#37/3-94CC Cont'd 506 Tulip Avenue
Takoma Park Historic District

*Rauitz
506 Tulip Avenue
Takoma Park District District
MPC 8/11/94*

506 TULIP AVE. - GARAGE

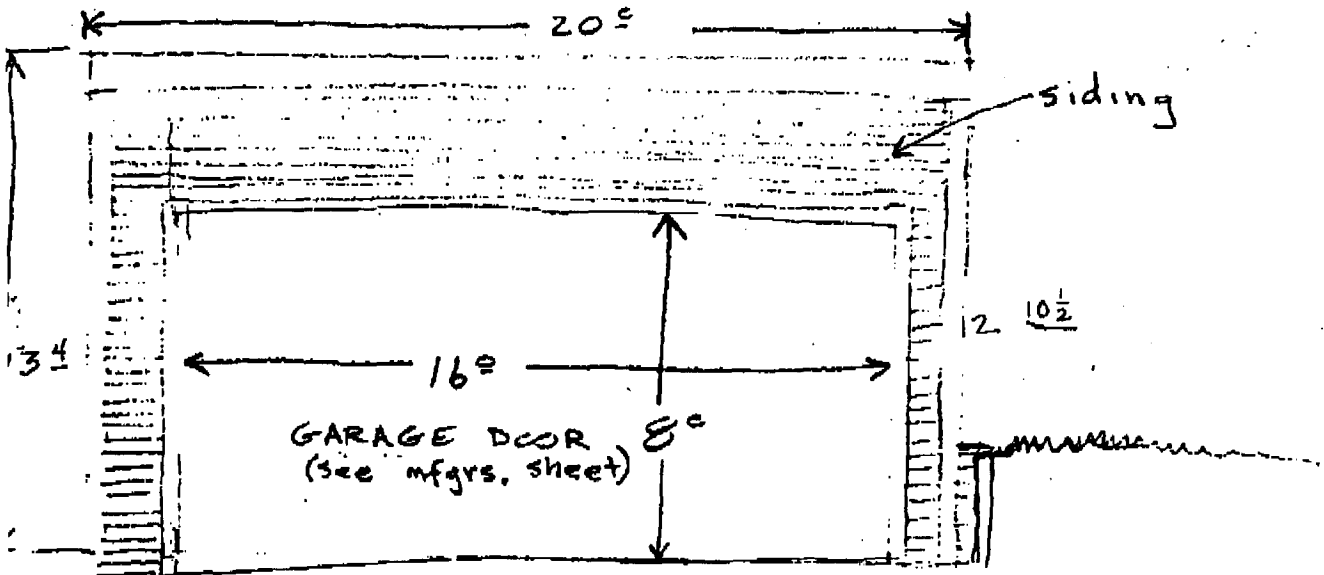
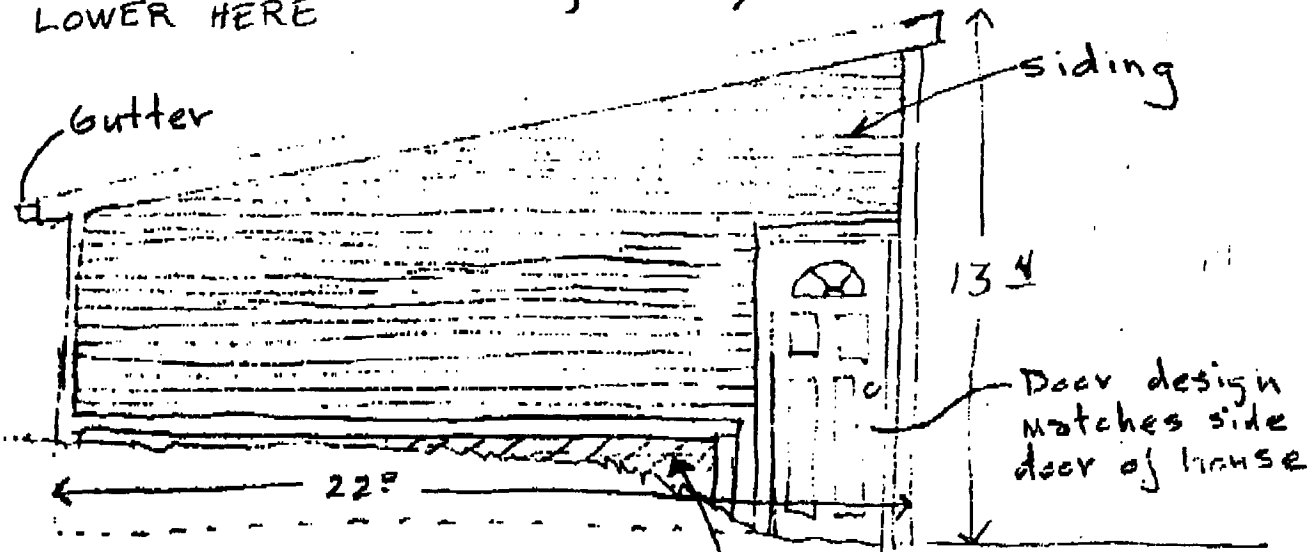
THE REVISED HEIGHTS SHOWN ABOVE ARE TO ACCOMMODATE THE MOTOR FOR THE GARAGE DOOR.

506 TULIP - GARAGE

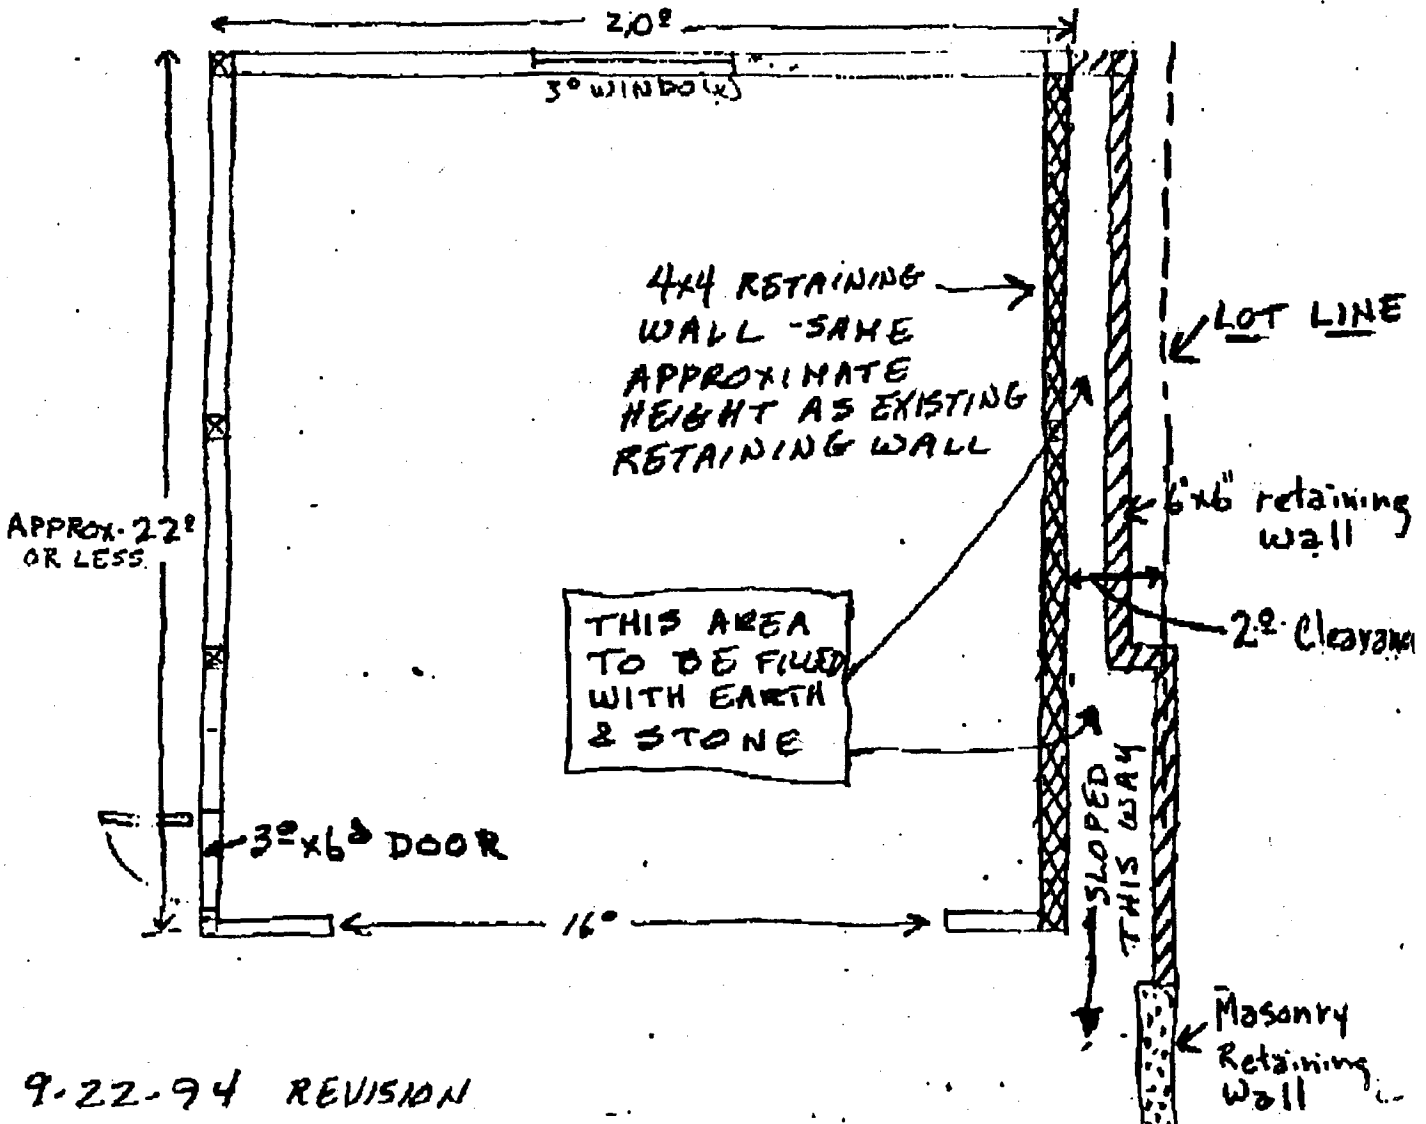
HPC note: Provide weep holes drilled in timber retaining wall 6' o.c.

506 TULIP - GARAGE

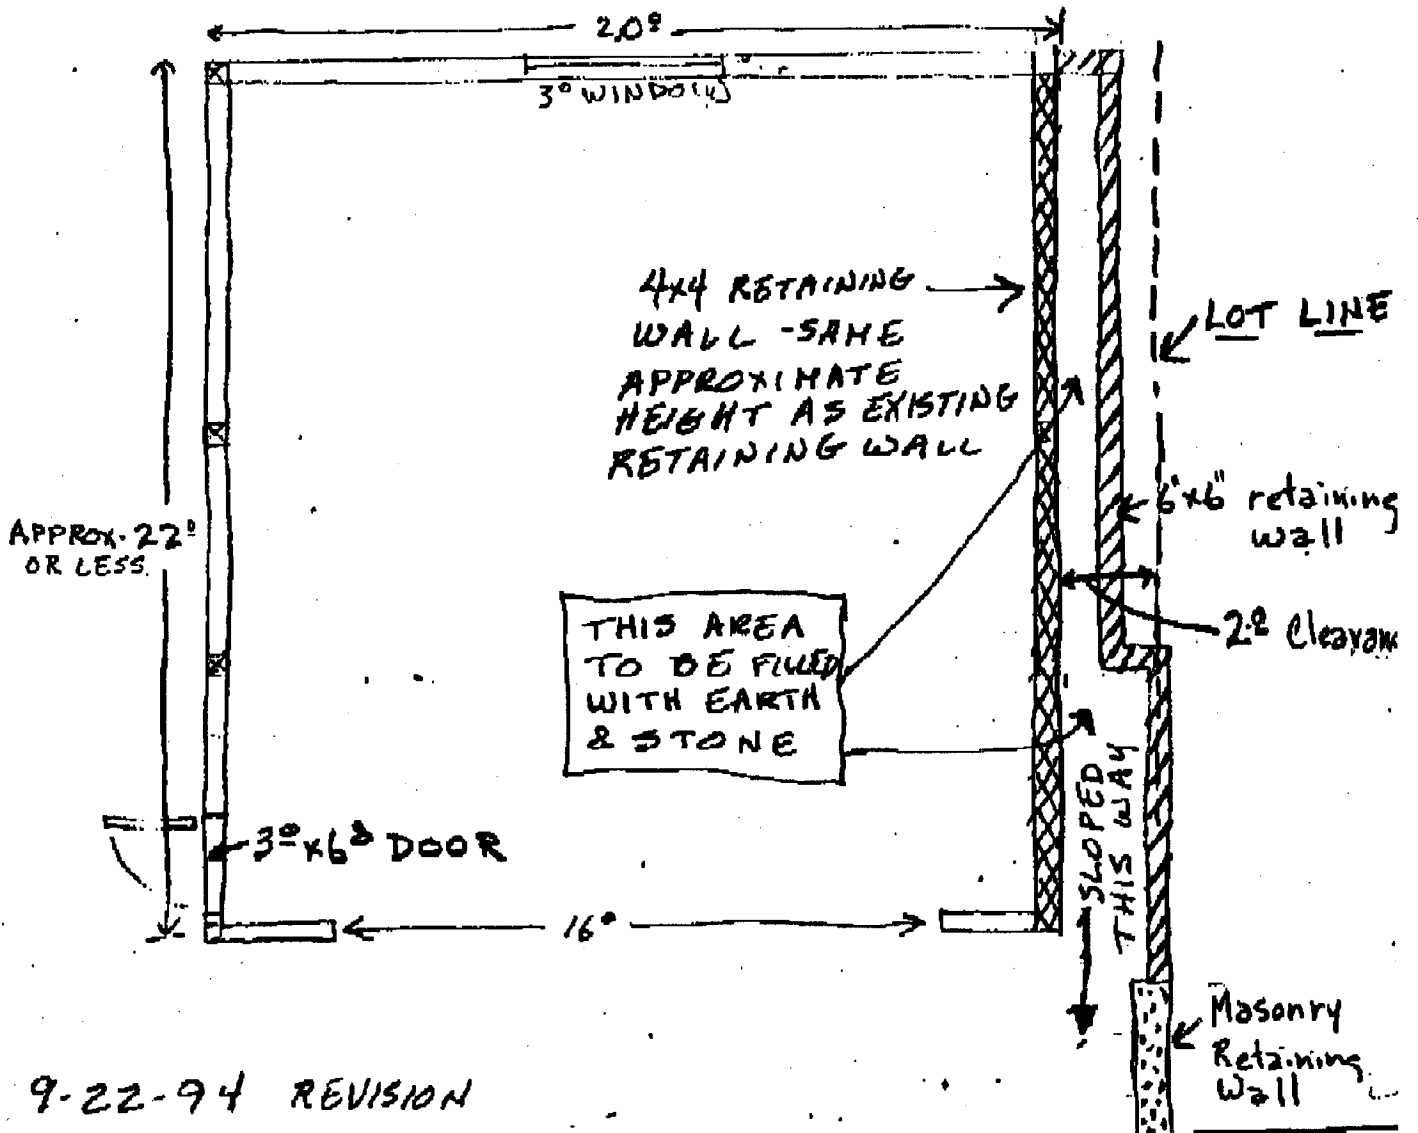
This revision to the garage plan allows me to shorten the garage (thereby gaining the turning radius). The garage length has been changed to read "APPROX. 22 OR LESS". The length will be between 18 and 22 feet. I am researching car and van lengths to determine the shortest practical length.

2x posts in conc.
staying well back. OK

DRAWING #1

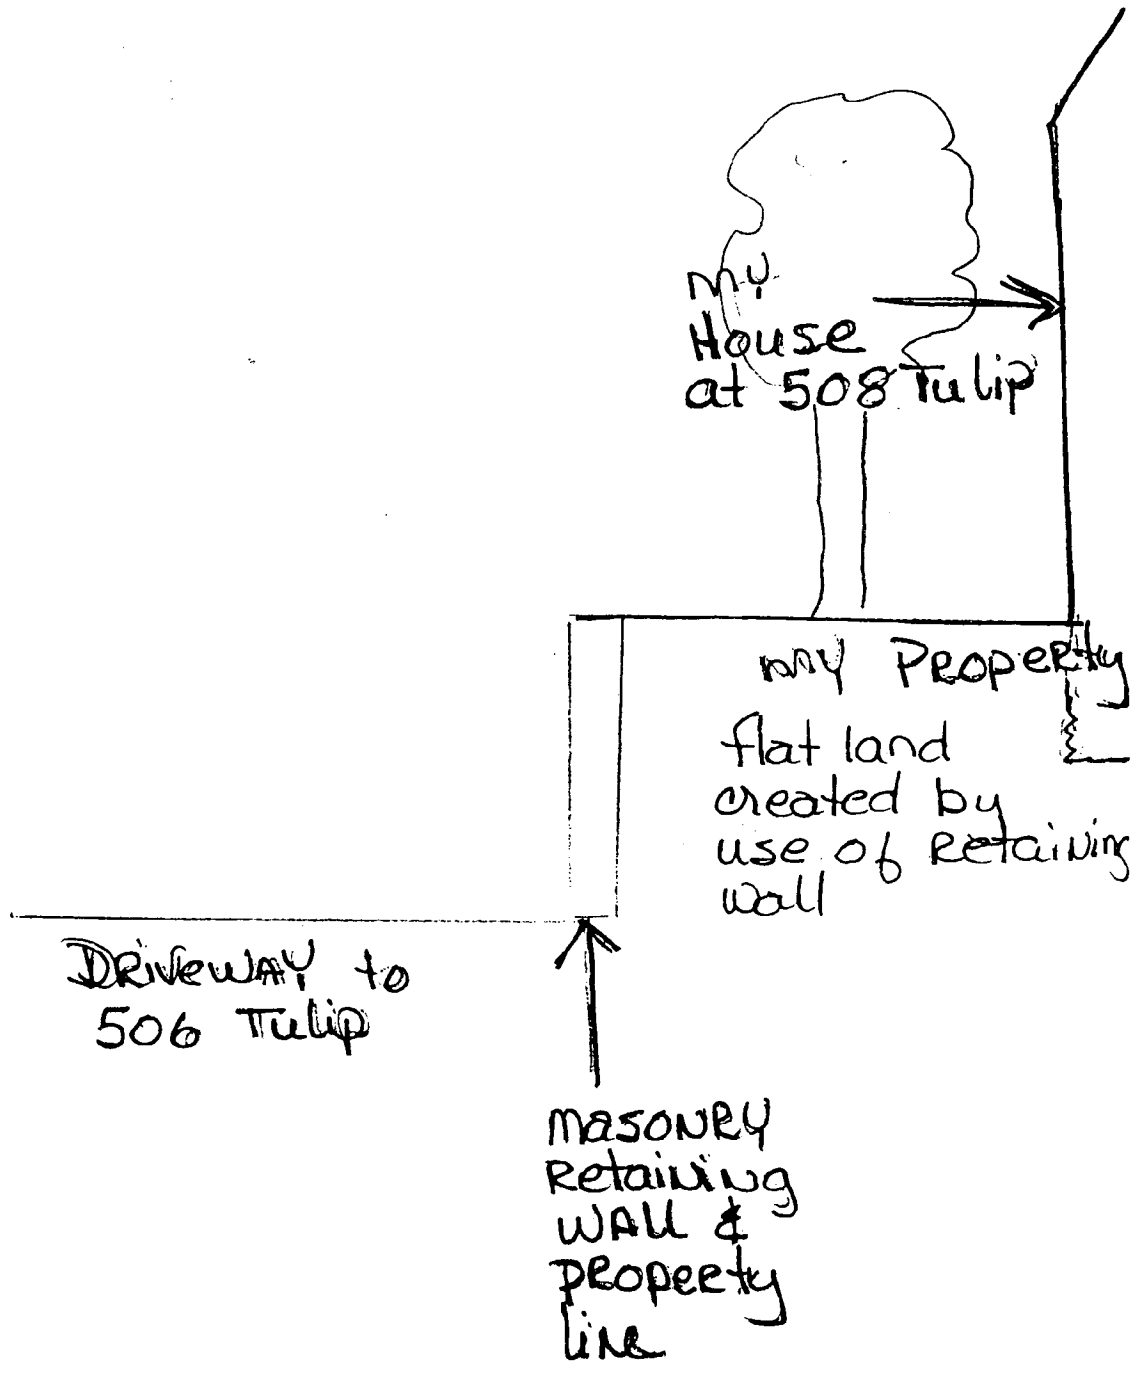
1. My house, circa 1911, was built on flat terraced land created by a retaining wall which runs from the front to the back of the property. **The structural integrity of my house is dependent upon the retaining wall.** Over the last 80+ years some of this wall did drift over the property line. This masonry retaining wall currently fluctuates in height from 2'1" to 2'6". It is contiguous to the driveway of 506 Tulip. Please see drawing 1.

4. The current plan for the garage, which adds approximately 7 feet to the original garage floor plan, creates a gap between the retaining wall and the garage wall which varies from approximately 6" to 1.5 feet. There is no provision for water drainage. Once the garage is constructed there will be no provision for repair of this 22' wood retaining wall from his side of the property line. The disintegration of this wall will cause erosion on my property which will in turn cause structural damage to my ~~retaining wall~~ property.

5. If the current plan remains unchanged, the only way that the wood retaining wall can be repaired or replaced is by taking a back hoe and ripping up approximately 1/3 of my yard at considerable expense. Again the structural integrity of my ~~retaining wall~~ depends on the retaining wall. The plans before

Drawing # 2 taken from applicant's package

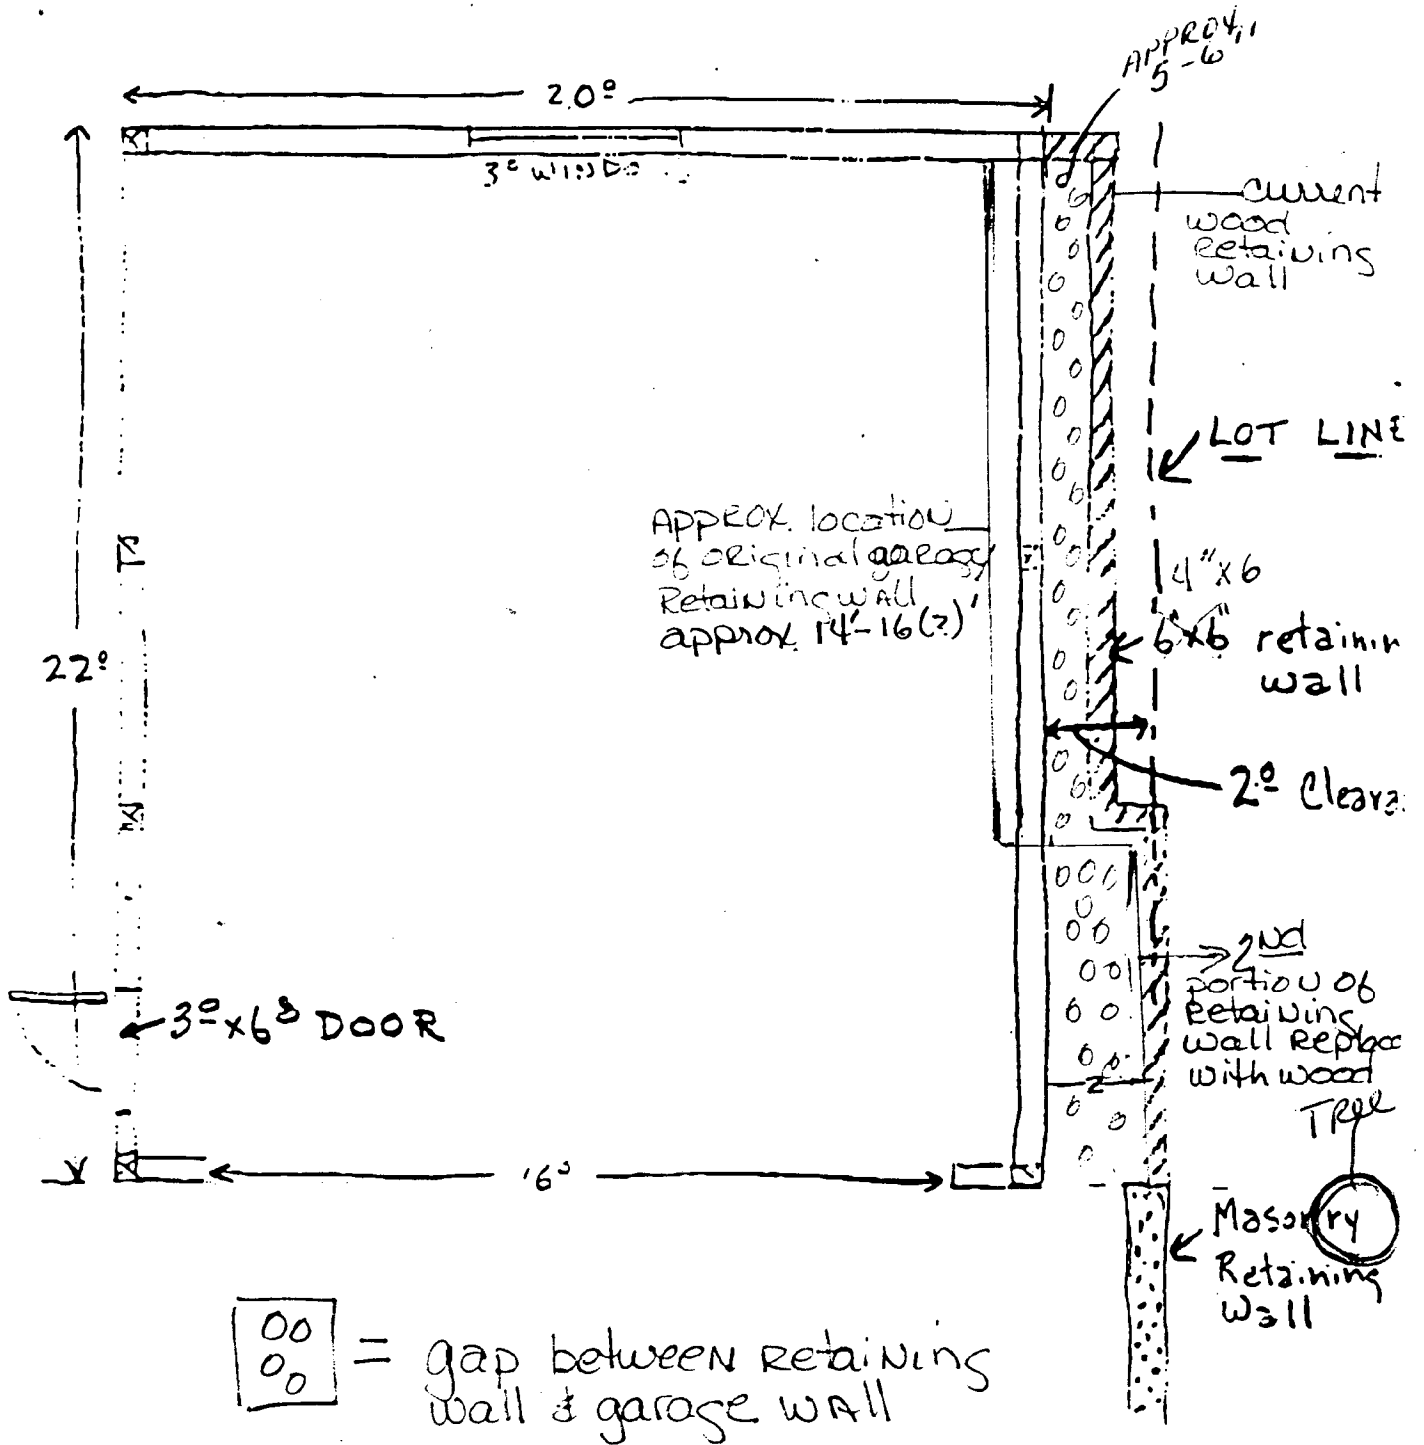
Note: In a conversation with the building inspector this morning, I learned that the "footings" for the garage/carport (and therefore the retaining wall) were done incorrectly. Most likely they will have to be redone. This is why Mr. Ravitz cut off the two on my side of the property.
